Project:	2022-RFT-024 821259 – 2022 Road Improvements - Apex - Hanson Drive Upgrades		
Addendum No.:	01	No. of Pages	4
Date:	April 28, 2022	Doc. No:	P7201-1928275642-115 (1.0)

**CITY OF IQALUIT**  
2022 ROAD IMPROVEMENTS- APEX: HANSON DRIVE UPGRADES

PROJECT NO. 212453  
SHEET NO. C3

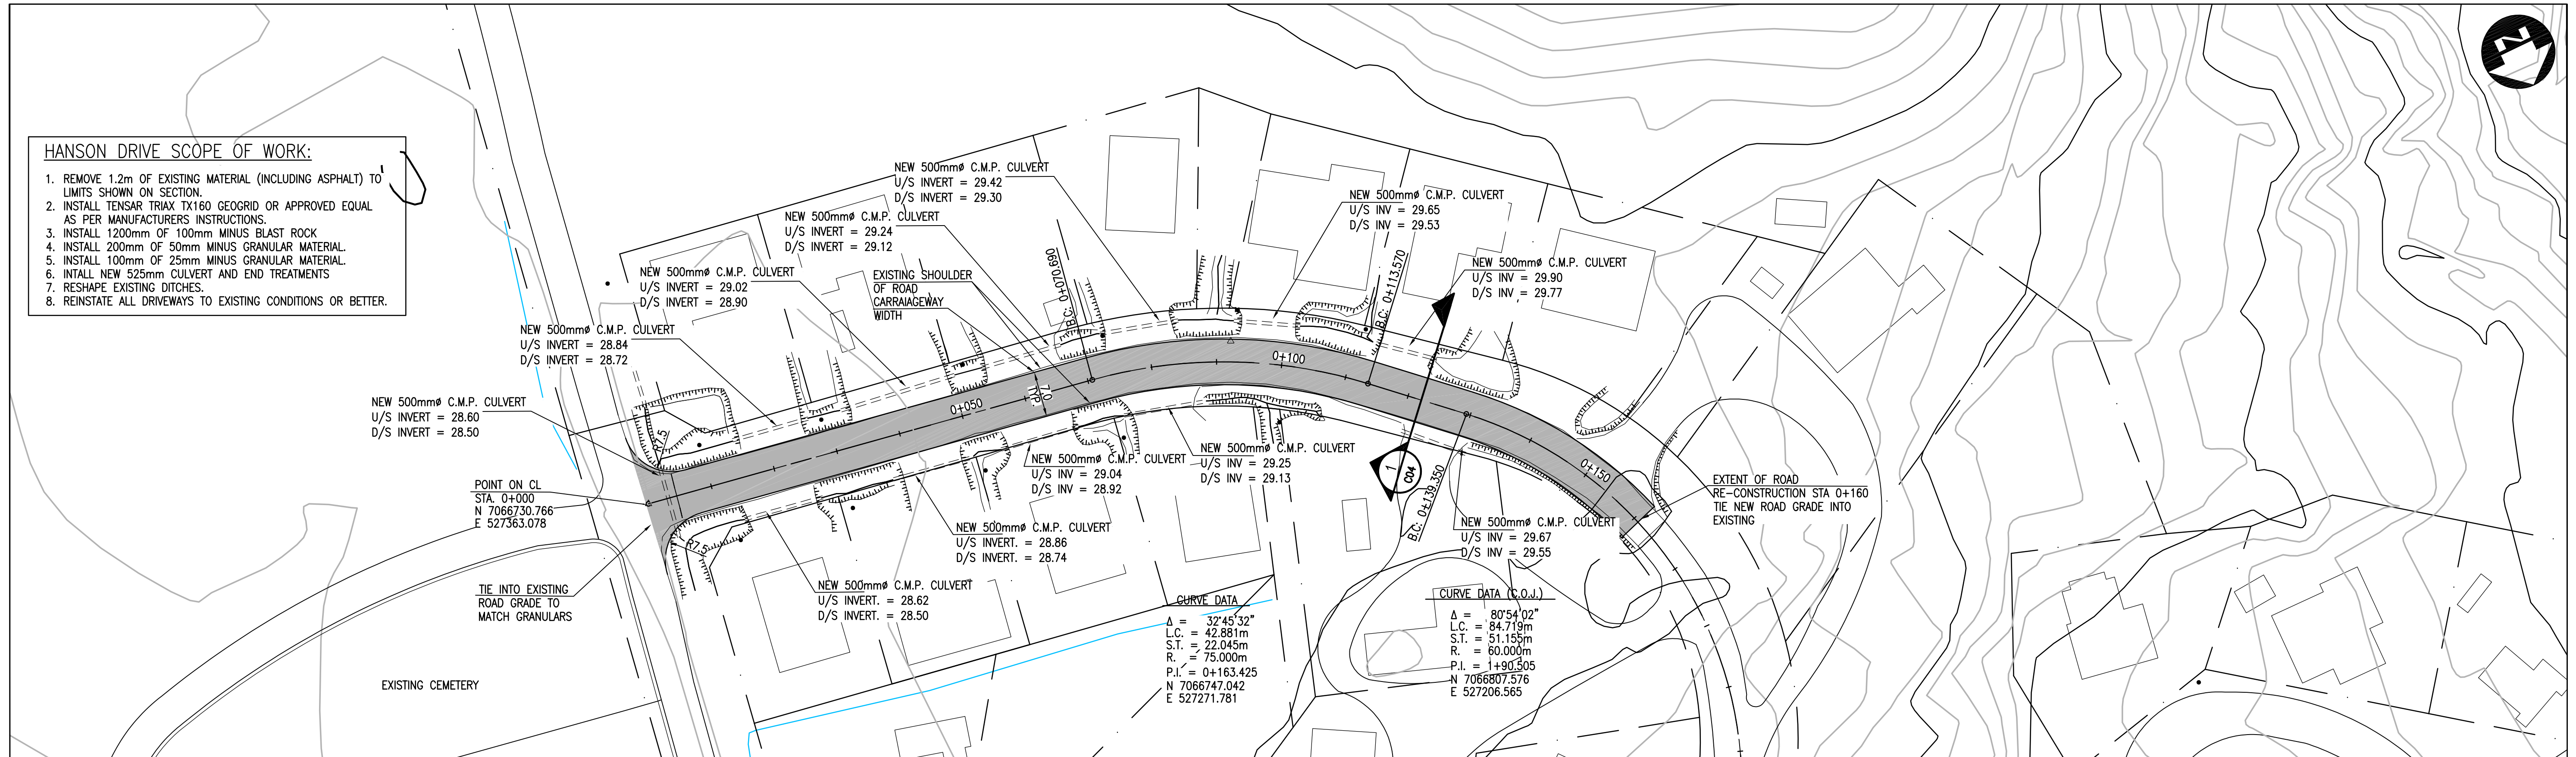
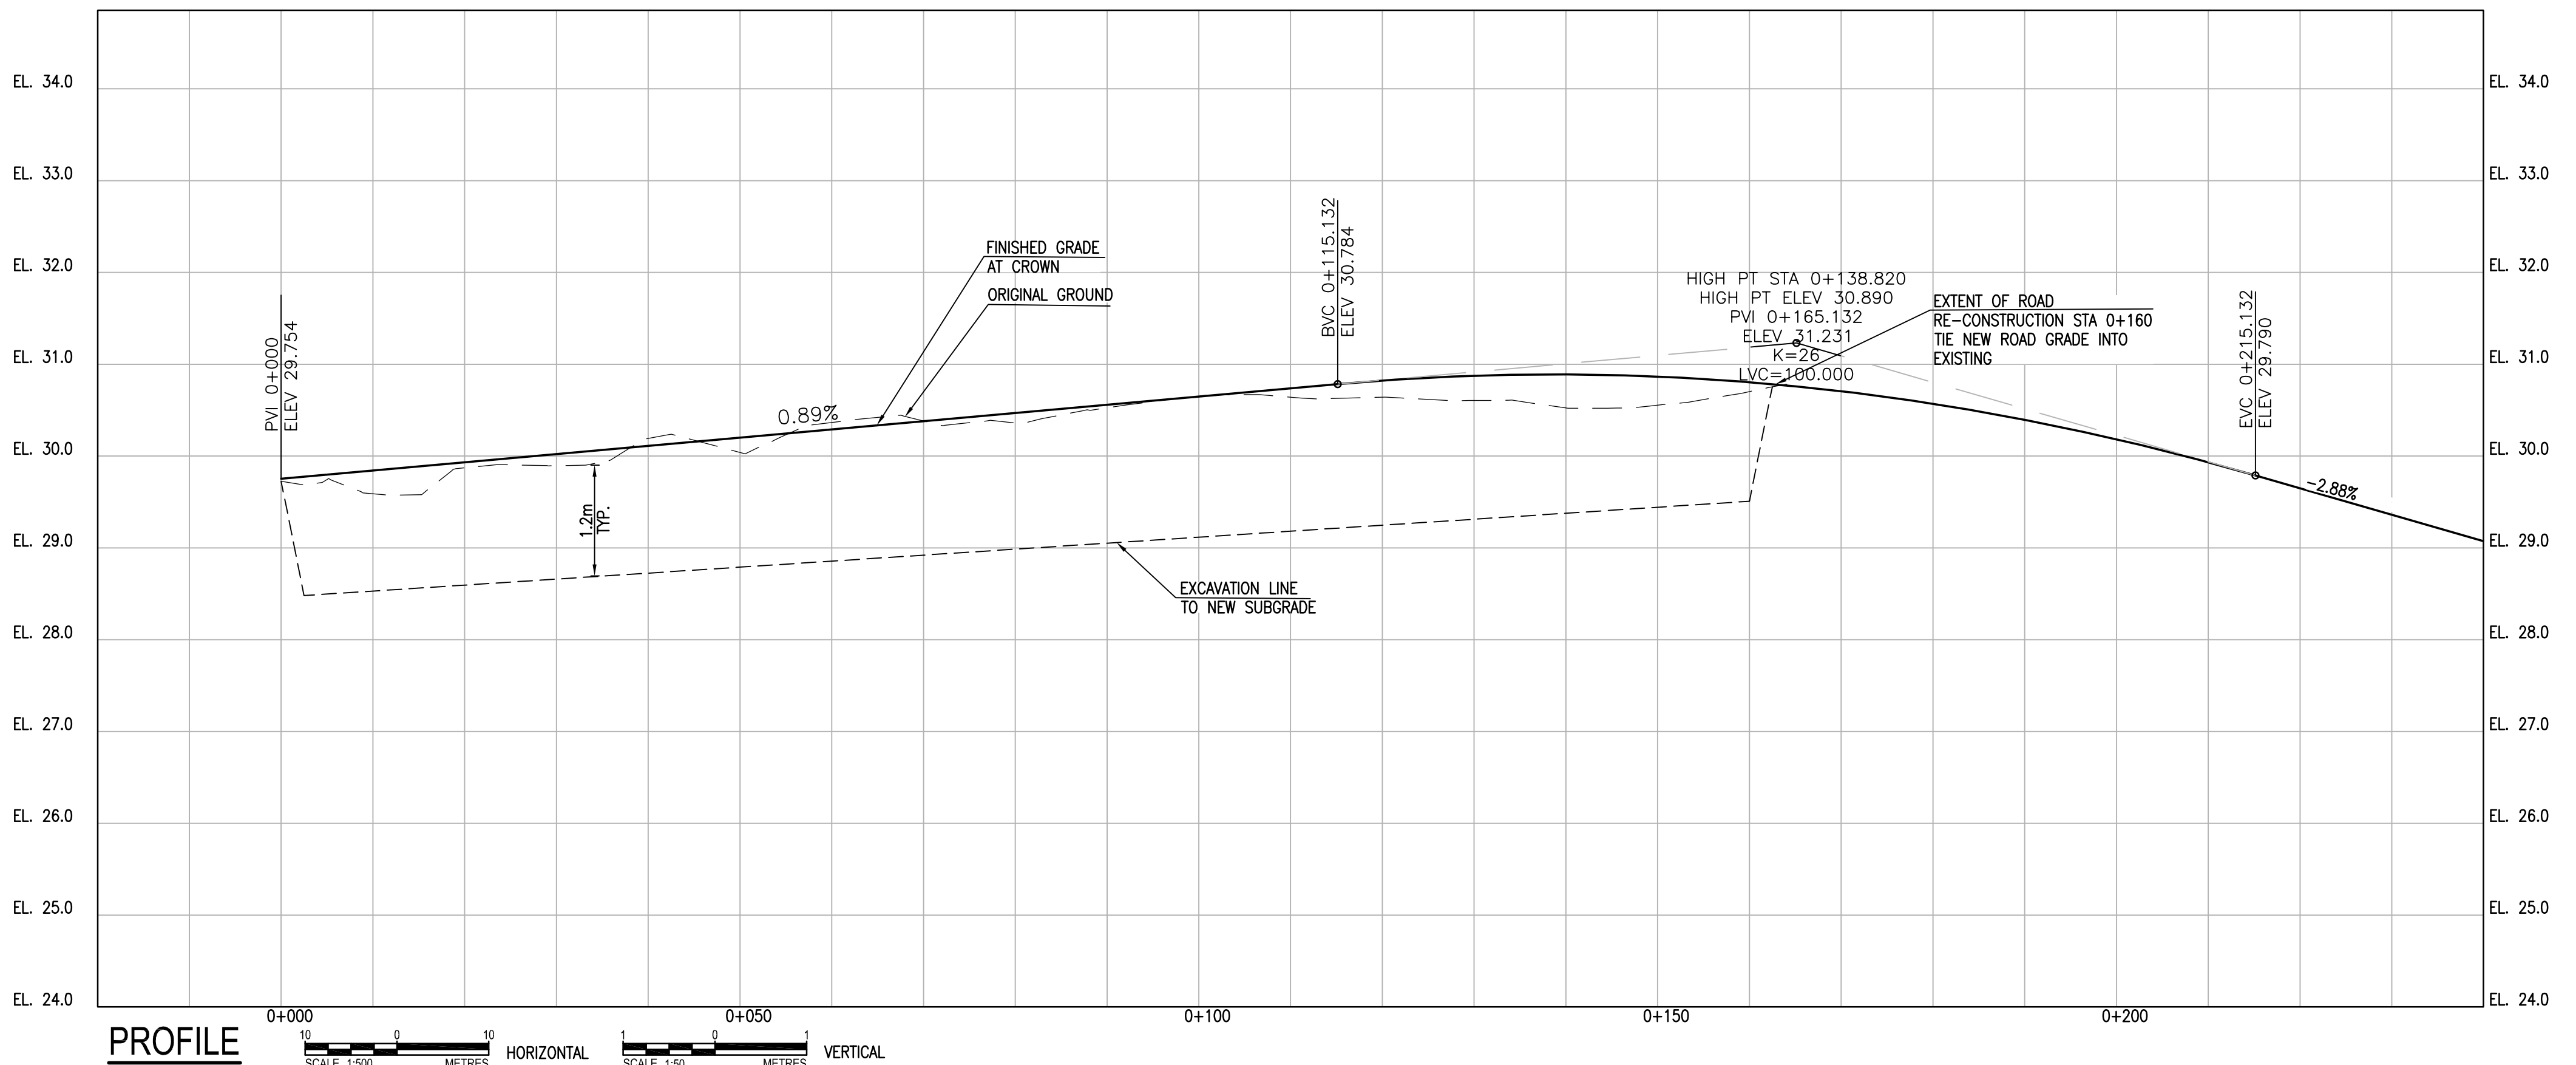
*Can you provide a design (elevations, slopes) of the ditches on both sides of the road? If no design, is a survey (CAD file) of the existing ditches available?*

*Φ525mm CSP steel pipe are identified as the replacement diameter for all the culverts on this project (sheet C3), but this diameter is not a standard in the industry. Can it be replaced by Φ500mm?*

*Dwg C3 shows a cross section referring to C/C16. Please confirm this detail is Det-1 on C3. If not please provide Dwg C16.*

**Please see attached Revised Drawing C-03. Culvert invert elevations are indicated on the drawing.**

**All new culverts shall be 500mm diameter galvanized corrugated steel pipe, meeting the City of Iqaluit Municipal Design Guidelines.**

**The correct cross section is shown on Detail 1/C4. We confirm that there is no Drawing C16.**
